Device	SAF-C161JI-32RF, SAK-C161JI-32RF, SAF-C161JC-32RF, SAF-C161JC-32RF, SAF-C161CS-32RF, SAF-C161CS-32RF
Marking/Step	Step (E)ES-AB, AB
Package	P-TQFP-128-2

This Errata Sheet describes the deviations from the current user documentation.

Current Documentation

New value of the additional jitter.

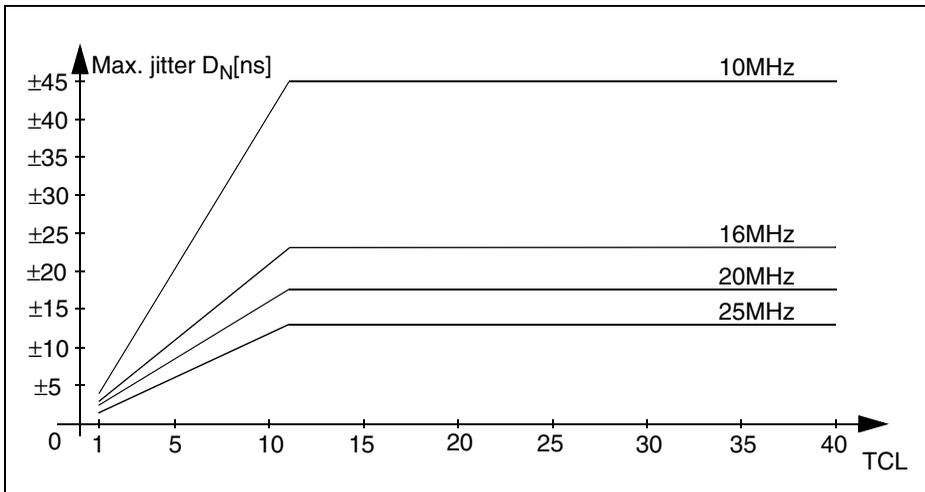
PLL.3.1 Increased PLL Jitter caused by external Access**Problem description:**

In systems where the PLL is used for generation of the CPU clock frequency, the PLL jitter can increase under certain circumstances and exceed the specified value.

The value of the additional jitter is not a fixed one but it depends on the kind of activity on the external bus or output pins. The additional jitter increases with the number of output/bus pins which are switched at the same time to a new voltage level because the problem is caused by noise on the on-chip power supply.

For an accumulated period of $N \cdot \text{TCL}$ the new maximum jitter $D_N[\text{ns}]$, which exceeds the specified value in the Data Sheet, is computed using the formula:

$$D_N[\text{ns}] = \pm[(50 / f_{\text{CPU}} + 164 / f_{\text{CPU}}^2 - 0.04) * (N / 2 - 1) + 1180 / f_{\text{CPU}}^2 + 0.2]$$

Were N = number of consecutive TCL, f_{CPU} = CPU frequency in MHz.

This approximated formula is valid for $1 \leq N \leq 12$ and $10 \text{ MHz} \leq f_{\text{CPU}} \leq 25 \text{ MHz}$.

For all accumulated periods longer than 12 TCL the $N=12$ value can be used; see figure below.

In case that the additional jitter causes problems in the system which cannot be relaxed with software adapted timing parameters, then direct drive or prescaler mode can be used. If the maximum frequency of the on-chip oscillator (16 MHz) is not sufficient then an external clock generator can be used.

Figure 1 C16x Clock Configuration

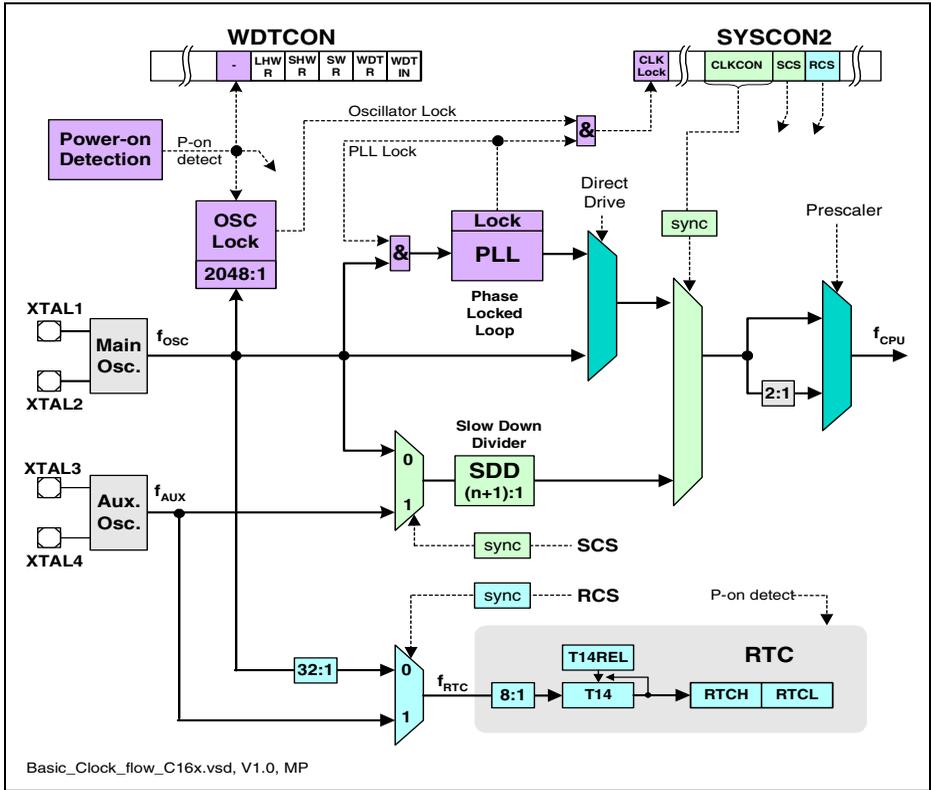
RST.18 Undefined Clock Configuration after Power-On**Problem Description**

During power-on or during a power off/on sequence it is possible that the internal clock configuration of the power management is not set to a defined state. An undefined state of the power management clock configuration can cause different kinds of malfunctions in the system. The below described malfunction does not always occur but can appear sporadically.

If the conditions to get a defined clock configuration at power-on are not fulfilled then it is possible that the internal power-on detection unit does not detect power-on. Whether power-on was detected or not can be checked with WDTCON.5. If power-on was detected then $\text{WDTCON.5} = 1$ else $\text{WDTCON.5} = 0$. The function of bit WDTCON.5 is implemented for evaluation purposes and is not guaranteed.

If power-on was not detected by the on-chip power-on detection unit then this can cause a malfunction of the internal oscillator lock detect unit. In that case the internal oscillator lock signal is not set after 2048 XTAL1 clock periods.

Effects on the system in case of an undefined Power Management Clock Configuration and possible Workarounds

Because of the high flexibility of the clock configuration during and after power-on, different cases of clock sources and clock paths have to be considered.

Consider the conditions to get a defined clock configuration at power-on.
